Responses-to-Comments (“R-to-C”) Table dated 14.6.2024

Table A Applicant’s Responses to Departmental Comments

PROJECT TITLE	PROPOSED REZONING FROM "GOVERNMENT, INSTITUTION OR COMMUNITY" TO "RESIDENTIAL (GROUP B)6" ZONE TO INCLUDE SOCIAL WELFARE FACILITIES (RCHE AND DCU ONLY) AND PUBLIC VEHICLE PARK (EXCLUDING CONTAINER VEHICLE) AT LOTS NOS. 148 S.A RP (PART), 148 S.B RP (PART), 149 RP, 150 S.A, 150 S.B AND 151 IN D.D. 206 AND ADJOINING GOVERNMENT LAND, WEST OF WU KAI SHA ROAD, MA ON SHAN, NEW TERRITORIES
DRAWING TITLE	SCHEMATIC ACCESS ARRANGEMENT WITH CONNECTION TO JUNCTION OF WU KAI SHA ROAD / YIU SHA ROAD (ROUNDAABOUT CONTROLLED)

Figure B

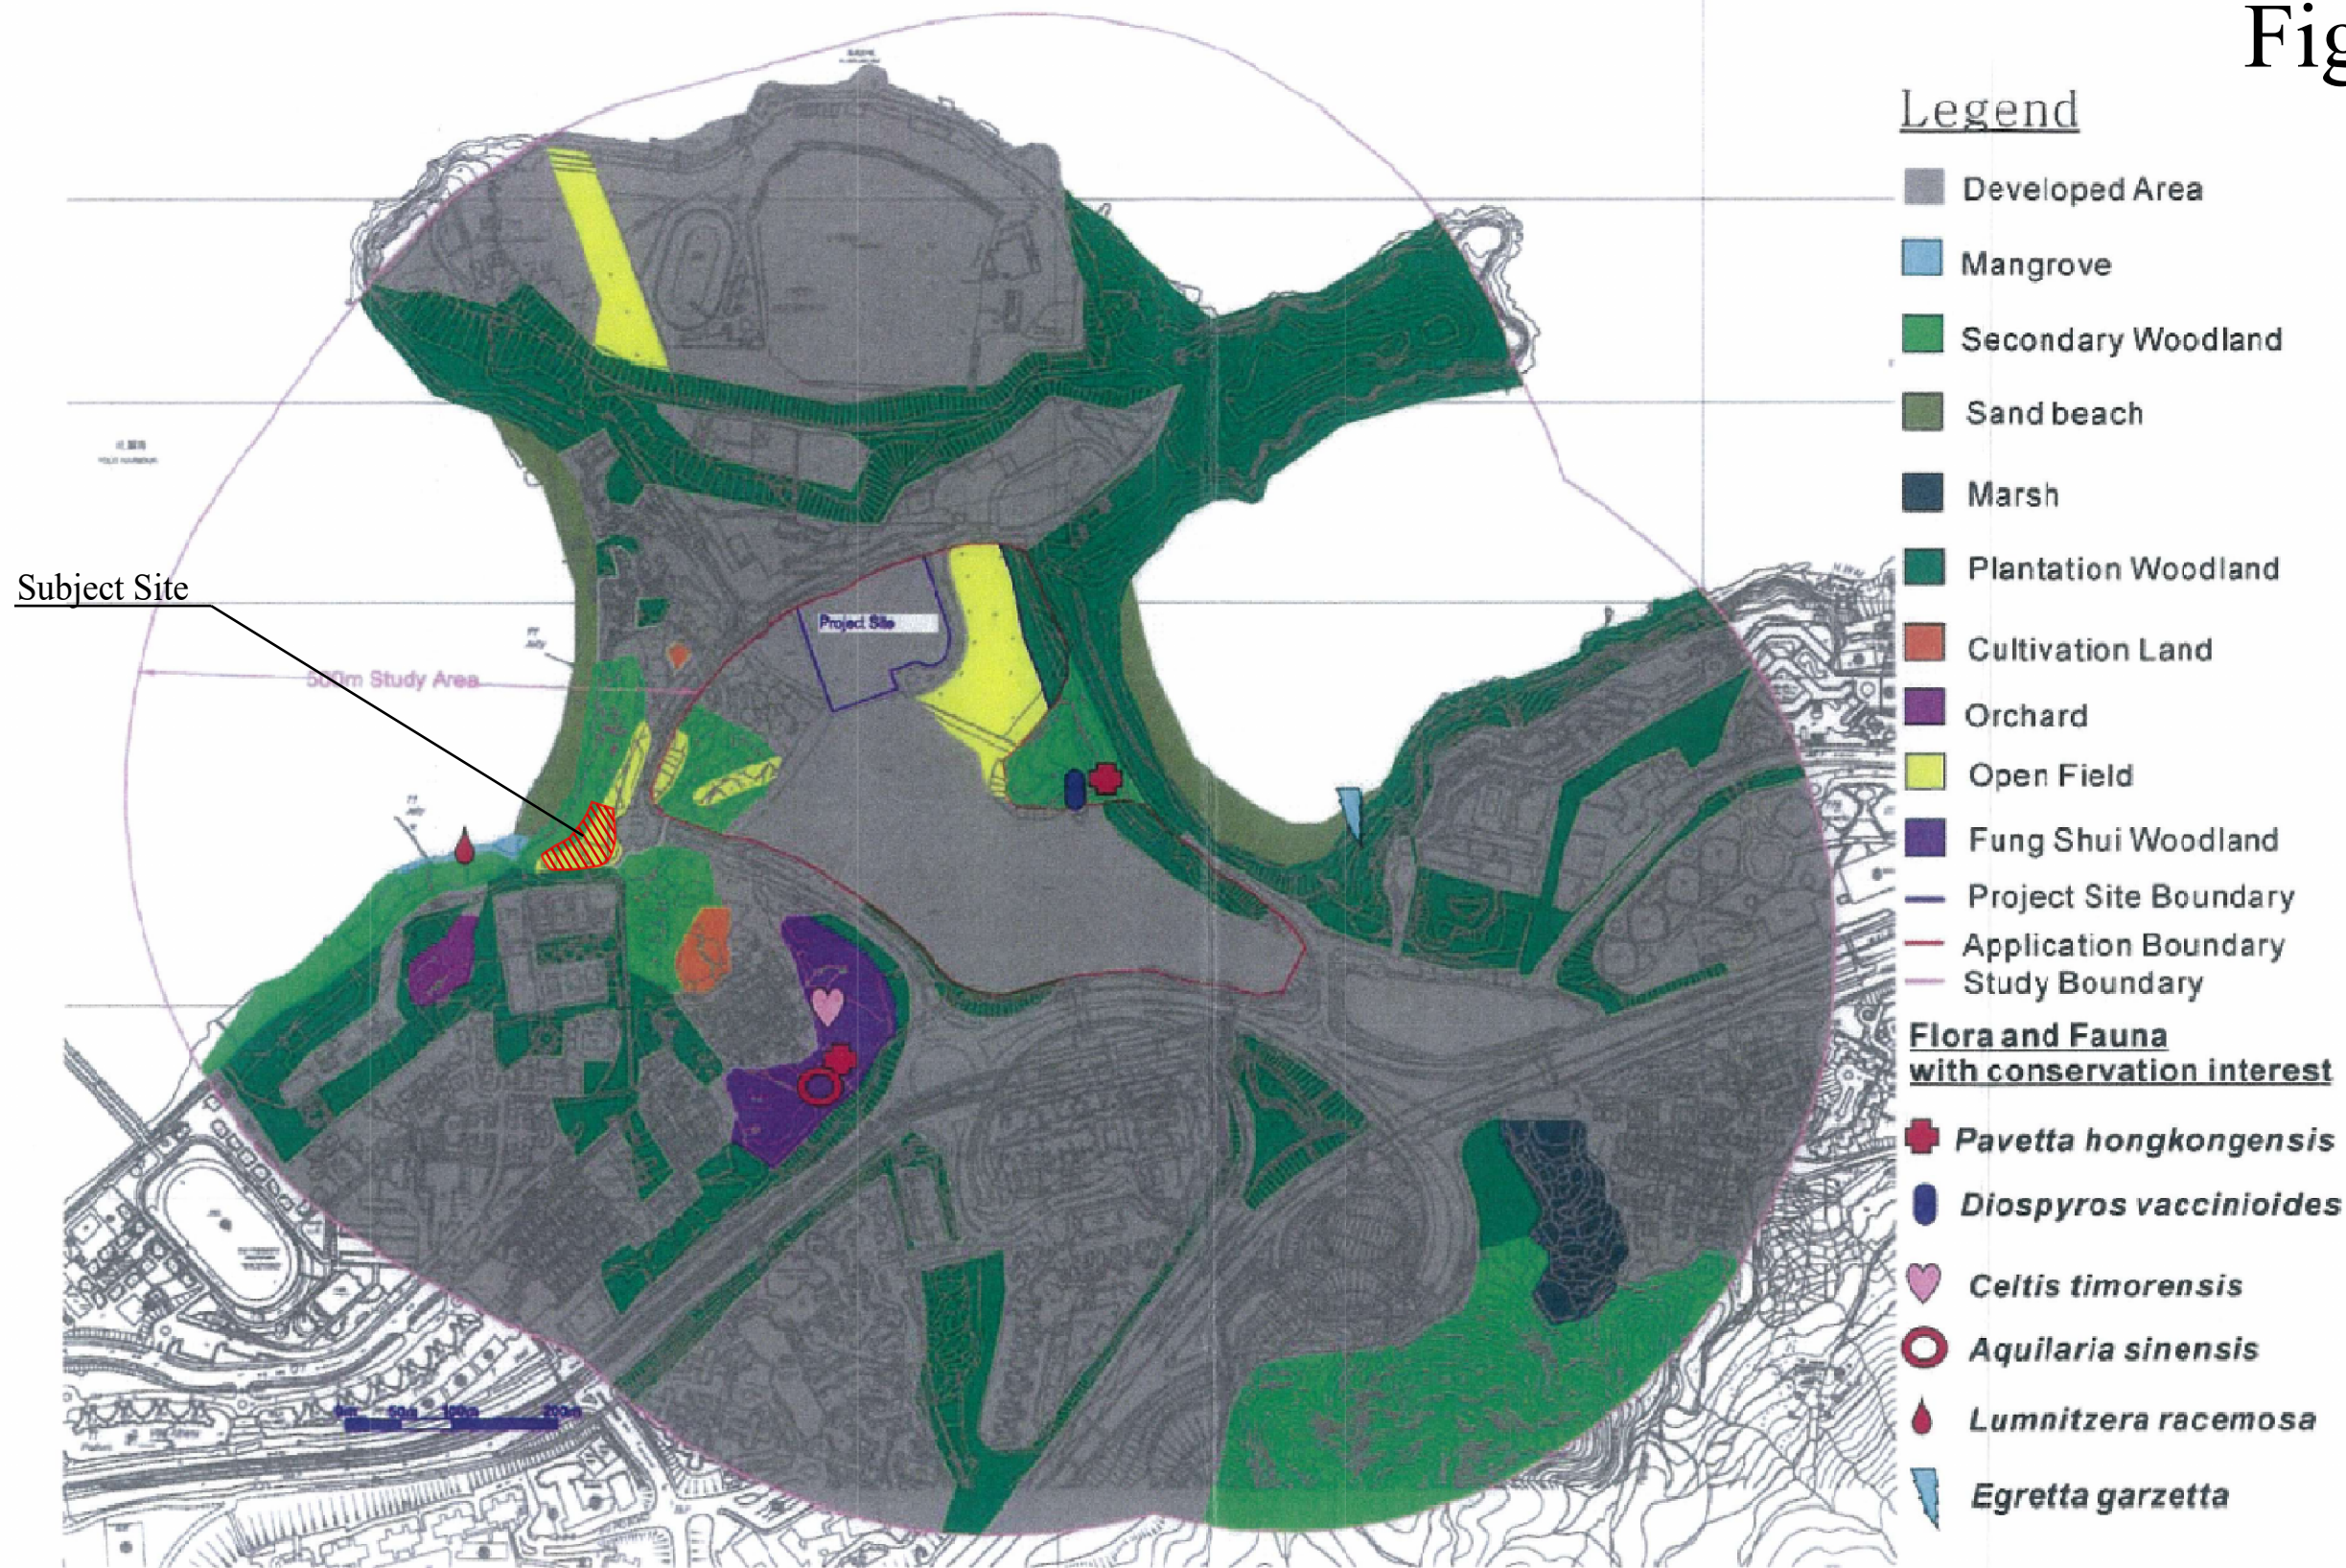
<p>E. Comments from AFCD (Received on 20.3.2024)</p>	
<p>1.</p>	<p>The proposed site covers a mature coastal woodland with some mangrove species recorded along the coastal area, which is just 35m away from the subject site. As such, the applicant should supplement an ecological assessment to demonstrate that the proposed development would not result in adverse ecological impacts on the coastal habitats and the species of conservation importance therein.</p> <p>Noting that some mangrove species are located about 35m away southwest of the Subject Site and are physically separated by a group of existing land uses, including paved footpaths frequently used by local residents and visitors, sand beaches, stormwater drainage open channel, commercial watersports facilities, sports ground, vacant land and vegetations, as shown in Figure A. Many of these existing uses are already being occupied by substantial and regular human activities.</p> <p>According to the Hong Kong Biodiversity (AFCD Newsletter between 2012 and 2023), two additional species (i.e. one is <i>Cynopterus sphinx</i> about 800m southwest of the Subject Site and</p>

Departmental Comments	Applicant's Responses
	<p><i>Orthetrum poecilops poecilops</i> larva in Che Ha, i.e. outside the Planning Area of Ma On Shan OZP) were identified in the Ma On Shan area, as shown in Figure B.</p> <p>Furthermore, with reference to the results of the Ecological Impact Assessment (“EIA”) (conducted in 2013) provided in previous planning application (Application No. A/MOS/96), the Subject Site was classified as Open Field and Secondary Woodland as shown in Figure C. No rare or protected plant species were recorded within these two habitats.</p> <p>For the proposed rezoning scheme,</p> <p>(i) the Applicant has taken at least 1 to 2m, and 3m setbacks from the existing footpaths to its west and southwest respectively, as shown in Figure 3a;</p> <p>(ii) the actual proposed site formation level at Ground Floor is about 5mPD, which will be about 2m higher than those in its surrounding footpaths, as shown in Drawing No. LD_04 in Appendix III (Landscape Proposals) attached to the Planning Statement;</p> <p>(iii) all on-site surface runoff will be collected and conveyed into the proposed manholes, and eventually to discharge to Tolo Harbour to the satisfaction of relevant Government departments;</p> <p>(iv) An on-site interim sewage treatment plant (“STP”) with equalization tank is proposed and to be implemented in accordance with all statutory requirements and to the satisfaction of relevant Government department. This STP will be disused once adequate public sewer capacity is available for connection; and</p> <p>(v) a row of new trees will be planted alongside the western and southwestern boundaries, as shown in Figure 21b. All these peripheral plantings are purposely acted as a soft screening measure</p>

DRAWING NO.	FIGURE T1	REV.	-
LLA 顧問有限公司 Consultancy Limited

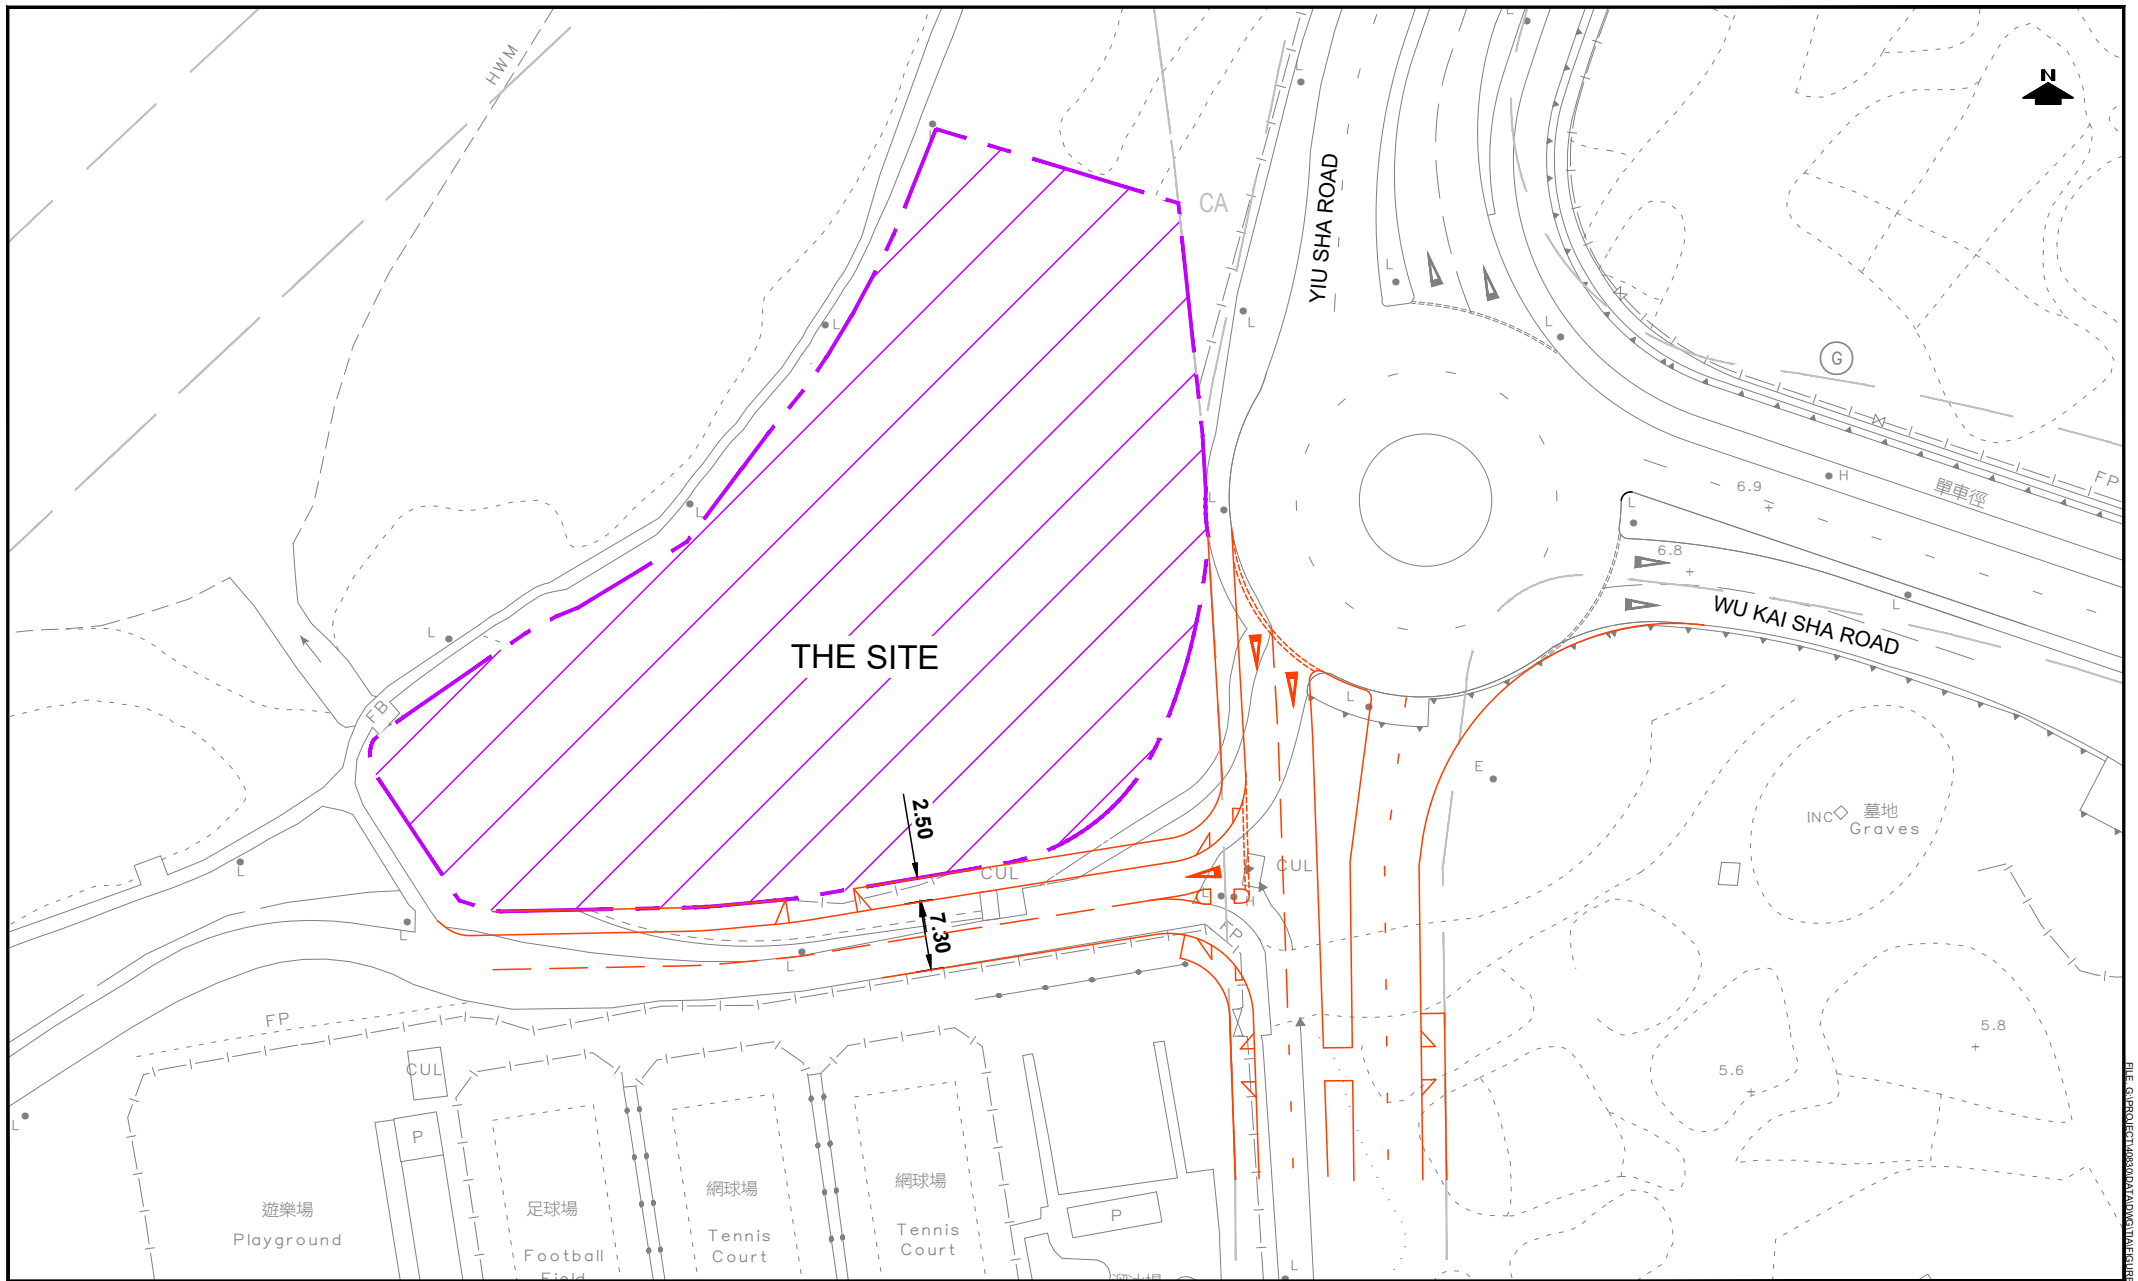
J.	Comments from TD (Received on 25.03.2024)	
	Major Comments	
1.	Figure 6.1 (Access Arrangement) –	
	(a) The applicant's R-to-C did not address our comment and we maintain our reservation on the proposed access arrangement. The applicant failed to demonstrate your proposed access road would be compatible to the planned new road between Wu Kai Sha Road and On Chun Street as shown in OZP no. S/MOS/27.	(a) Without any details about the future junction traffic arrangements of the planned new extension of On Chun Street and Wu Kai Sha Road, an indicative elaborated access arrangement, including both roundabout controlled and signal-controlled schematic layouts, for the proposed rezoning development is now attached on Figure T1 and T2 .
